THAMES CROSSING ACTION GROUP

As a group we remain strongly and completely opposed to the proposed Lower Thames Crossing.

Confusion over amount of noise barriers 17 v 19

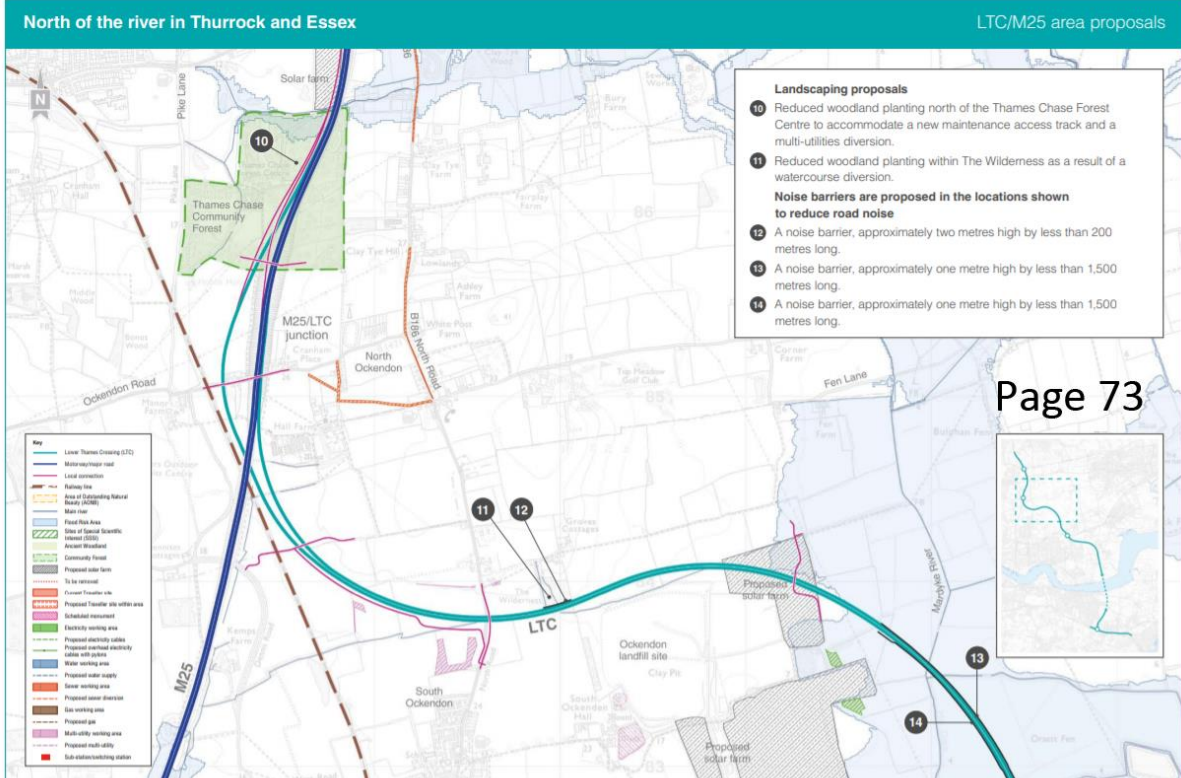
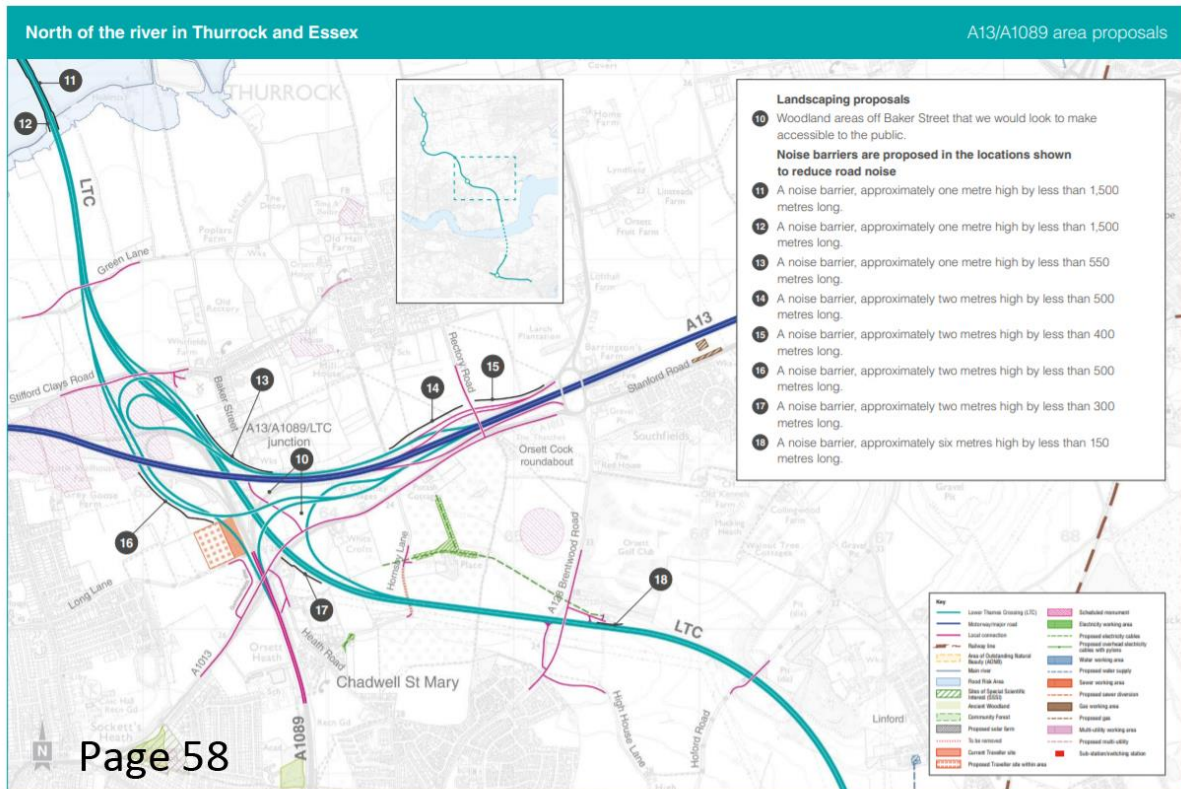
We and many others have been confused over the amount of proposed noise barriers. When you go through the consultation guide and count them in total there are mentions of 19 noise barriers. We raised this point with HE only to be told that

We would state that this is not at all clear to any of us. There is no reference of this in the descriptions that they are duplicate showings of the same noise barriers. Plus the way the maps are presented means they are cropped in a way that means there is no common point of reference to identify that these are the same noise barriers, and they are on a different angle so it looks more like an extension of the road, rather than being in any way obvious that it is the same location. We have always assumed this was a continuation rather than an overlap, as there is nothing to identify that fact. Yet another example of the inadequacies and lack of clear and informative materials from HE.

“Two of the barriers (11 & 12) on the map on page 58 (top left) are repeated on the map on page 73 (13 & 14, bottom right)”
